Sent: Fri May 30 11:03:19 2008 Subject: development opinion.

Sent: Fri May 30 09:54:18 2008 Subject: Comments on DEIS for SFC

The Yonkers Downtown Business Improvement District submits the following comments related to the Struever Fidelco Cappelli LLC Draft Environmental Impact Statement.

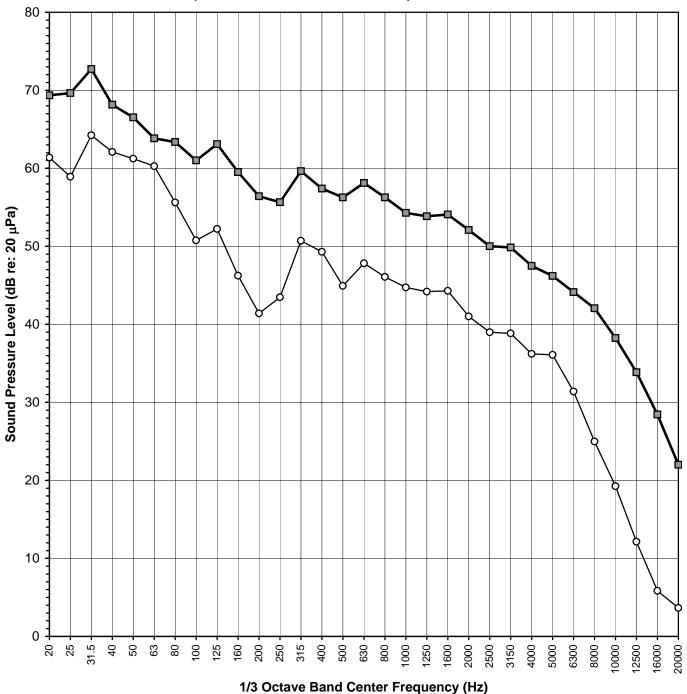
The attached Figure 1 (attached hereto as **Exhibit "A"**), prepared by CTA, presents estimates of ASR facility impacts on proposed residential spaces. These data indicate that ASR sound levels are expected to be as high as 65 dBA at the nearest residences at the south end of the development (5 story residential/retail), and could reach 55 dBA at the south face of the 25-story south tower. Since ASR operates continuously, these sound levels might occur during both daytime and nighttime periods. Given that Palisades Point will introduce residential land uses adjacent to ASR's refinery, and given that the

ASR Sound Levels at Outdoor Recreational Locations

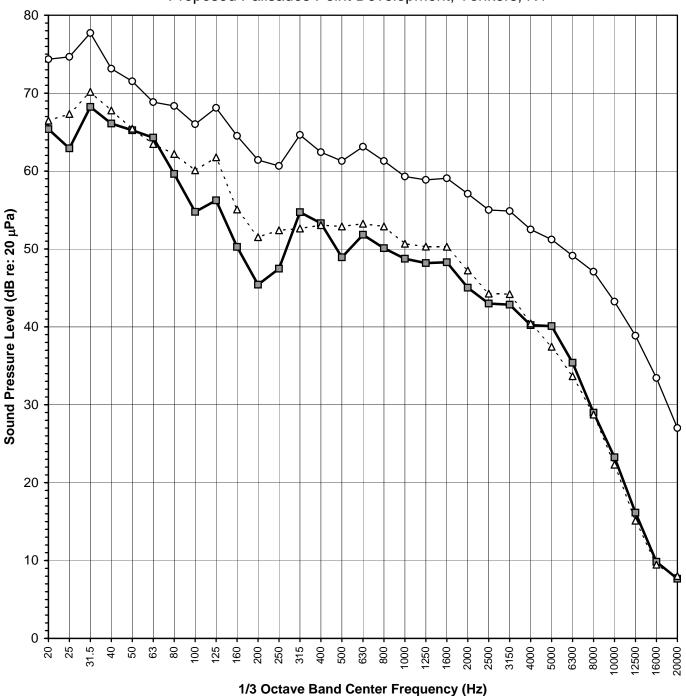
Figure 2 (attached hereto as Exhibit "B"), also prepared by CTA, presents estimates of ASR sound levels at various outdoors locations on the south side of the Palisades Point site. These data indicate sound levels that range between 60 to 70 dBA. The DEIS also suggests that no performance standards with respect to noise have been promulgated for the proposed Palisades Point project. However, the DEIS fails to explain how the placement of residential structures adjacent to ASR's sugar refinery will comply with the Yonkers Code for residential areas.

Figure 5-1 Frequency of Occurrence of 1-hour Maximum Cogen SO₂ Concentrations ≥ 500 μg/m³ on the Proposed Palisades South Tower

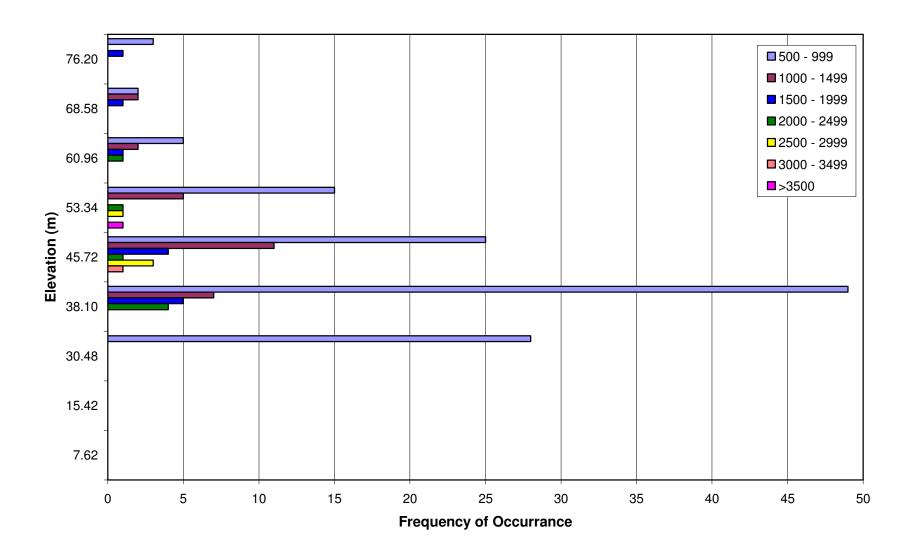
The results of this analysis are presented in Figure 5-1 for the cogeneration unit. Figure 5-1 shows the 1-hour SO_2 concentrations above the threshold are predicted to occur most frequently at the 38.1 meter (125-foot) height, or half-way up the face of the South Tower. The maximum 1-hour SO_2 concentration was predicted to occur at the 45.72 meter (150-foot) height. One-hour concentrations above $500 \, \mu \text{g/m}^3$ are predicted to occur infrequently (total of six hours over the five-year period) at the top of the South Tower (i.e., at the proposed location of the building air intake vents).

Figure 5-2 Frequency of Occurrence of 1-hour Maximum Boiler No. 3 SO₂ Concentrations ≥ 500 μg/m³ on the Proposed Palisades South Tower

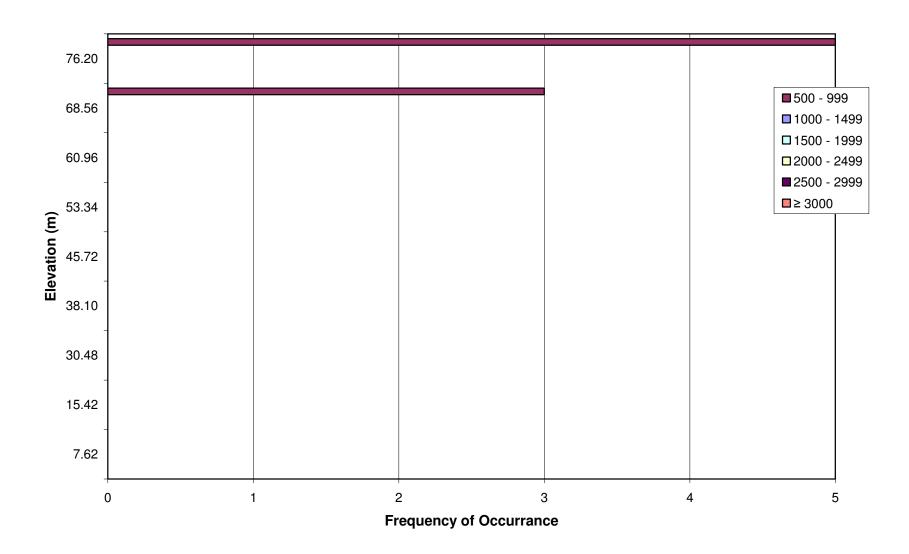
Figure 5-2 presents the results of this analysis for Boiler No. 3. As shown in Figure 5-2, the plume from Boiler No. 3 is predicted to infrequently impact the South Tower at concentrations at or above $500 \,\mu\text{g/m}^3$ (a maximum of 8 hours per year over the five-year modeling period). In addition, the maximum 1-hour SO_2 concentration is less than $1000 \,\mu\text{g/m}^3$. This result, coupled with the fact that the SO_2 emissions from Boiler No. 3 are greater than for the cogeneration unit, suggests that the Boiler No. 3 plume centerline height is higher than the South Tower when the plume SO_2 concentration is $500 \,\mu\text{g/m}^3$ or greater.
